**ALERT SERVICE BULLETIN**

**206-16-135**

**SUBJECT:** Air Conditioner Compressor Pulley Installation,  
Fastener Change

**Title:** SB 206-051616; Bell 206 Air Conditioner Compressor Pulley Install Fastener change

Figure 1. Compressor Pulley Installation configuration

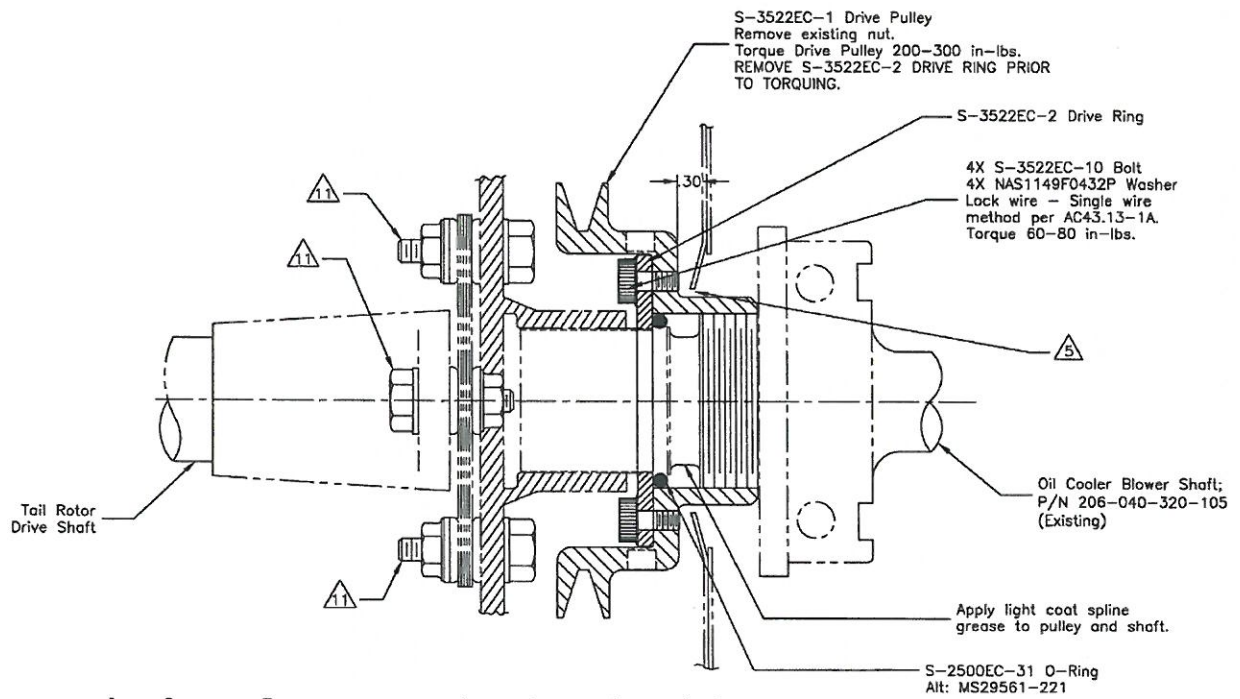
Referring to Figure 1 on Sheet 2, the installation of the ACC air conditioning pulley onto the tail rotor drive shaft involves separating the Thomas coupling joint by removing the set of four fasteners at the joint (identified by flag note 11 in the view). The air conditioning kit has included a set of new fasteners including specialized bevel washers to replace the OEM hardware at this location. ACC has become aware that the fasteners provided in the kit were a larger diameter than the original fasteners on earlier models and therefore were unable to have been installed. The ACC supplied beveled washers however could possibly have been used with the OEM fasteners because of their larger bore size.

The required action is to verify that only the OEM fasteners are in place, including the OEM bevel washers, and that the placement and direction of the bevel washers are per the Bell Service Document 65-99-00.

The ACC drawing covering the installation of the compressor pulley has been revised to call for the replacement of the OEM fasteners as shown in note 11 of Figure 1 on sheet 2.

Re-use pre-existing hardware including bolts, flat washers, bevel washers and nuts. Install, torque and safety wire per Bell service document 65-99-00, paying special to the location and direction of the bevel washers. (Sht 11)
